## 1 MUSEUM STREET, LONDON WC1A 1JR

Application for planning permission: 2021/2954/P

4 August 2021

**Save Museum Street**, which comprises the organisations listed below, objects to this application and a summary of our concerns follows. These are set out in the following sections:

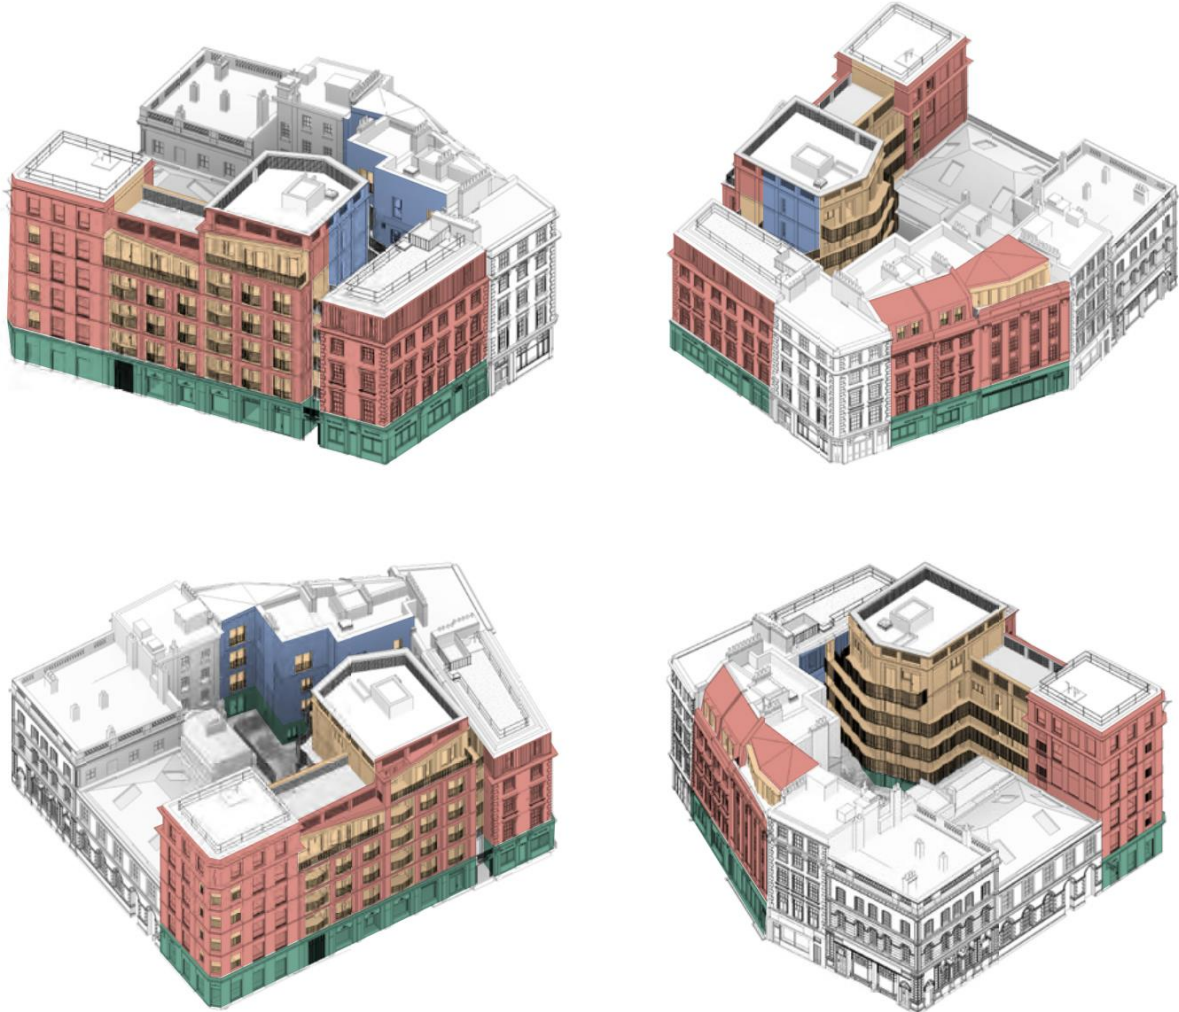
7.2.3 In LabTech’s open space calculations they have included the public footpaths along West Central Street and Museum Street and the paved area of Vine Lane that is likely to be gated. They state the public open space they are providing is 1,860 sqm. In this figure they have included the taxi drop off point and have also included the area under the office tower arcade that is to be built on the current open area in front of Selkirk House opposite the Post House. The office tower occupies a greater area at ground level than Selkirk House. It will be some 5m closer to Museum Street and some 2/3m closer to West Central Street. The current paved area between The Post House and the proposed tower block will be significantly reduced. Labtech give the current public open space as 1,331sqm again including the public footpaths and taxi drop off point. The difference is 529sqm which is the Vine Lane pavement area.

7.2.6 What should be provided to comply with Camden’s Open Space policies is set out in Camden’s Open Space Planning Supplement 2021 edition see page 6. The area that is required be provided as NEW public open space should be a minimum of 784sqm

7.2.10 Labtech are deliberately endeavouring to give the impression that they are providing new public open space when they are not. They are upgrading surface treatment of the pavements and roads nothing more and these improvements are all to do with their commercial aspirations.

Play space for the housing

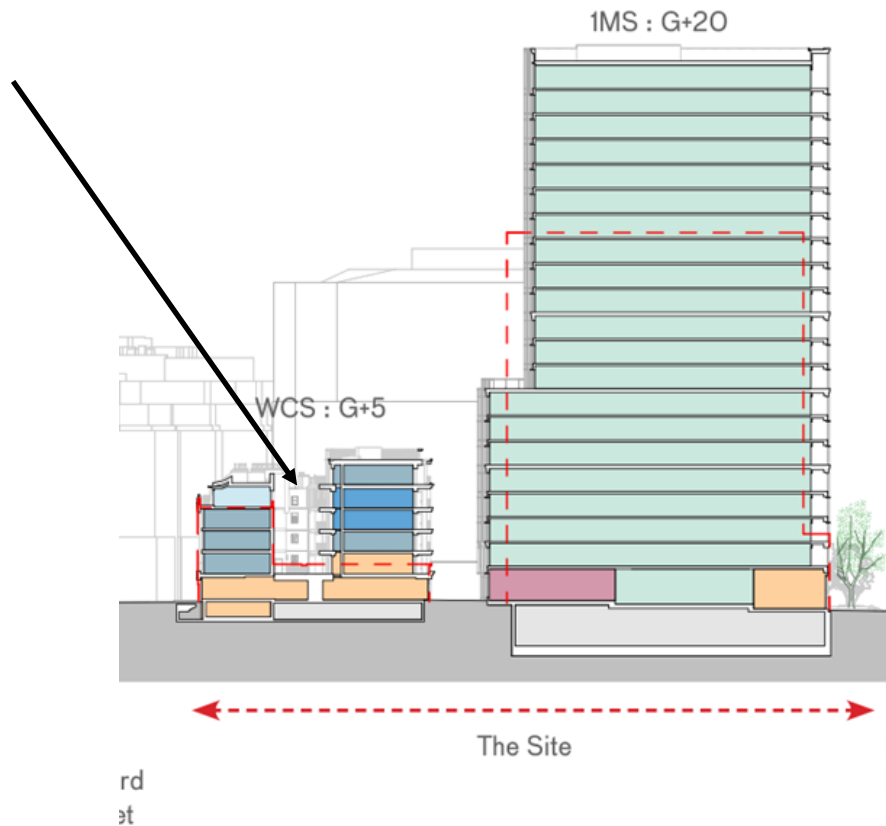
E and F. Applying the formula and applying LabTech’s non-compliant housing figure of 29 new dwellings, the minimum area of play space/open space should be 380 sqm, some 250% too little.

7.3.2 The actual play space that Labtech is providing contains no play facilities (unless a few timber posts stuck in a planted bed as is illustrated constitutes a play facility). In addition, the courtyard is primarily a circulation route to give access to the housing accommodation separated by some very small planting beds, and due to the excessive office tower height and the height of the immediate buildings surrounding the courtyard, it will be very dark and oppressive. It certainly will not be an attractive play area for the housing.

7.3.4 And the sectional drawings below show how the height and bulk of the proposed office tower will completely overwhelm the housing proposed between West Central Street to New Oxford Street, particularly that facing West Central Street and its shadow will take away daylight and sunlight for most of the year from the so-called open space play area.

A sectional drawing showing Vine Lane cut through the site viewed from High Holborn and totally overwhelmed by the proposed office tower rendering it dark and in shadow most of the year round.

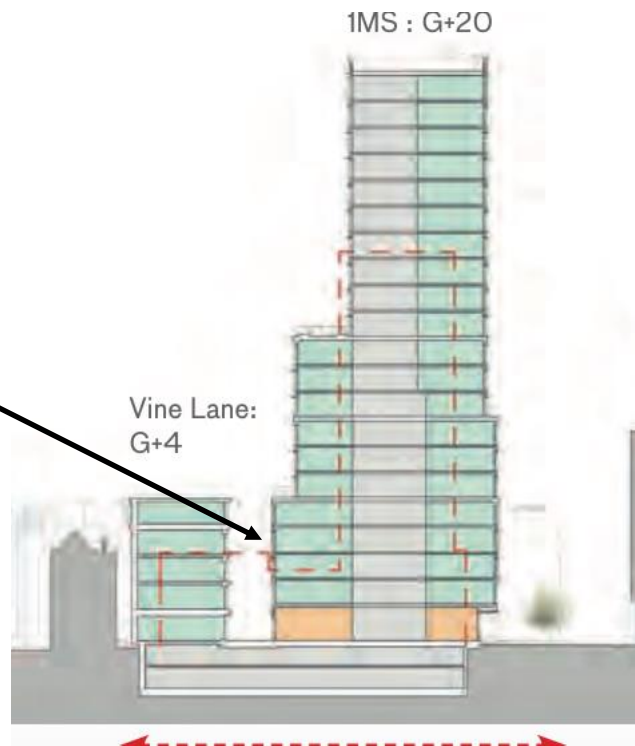
We do not consider this element of the scheme desirable and it is very likely to attract anti-social behaviour.
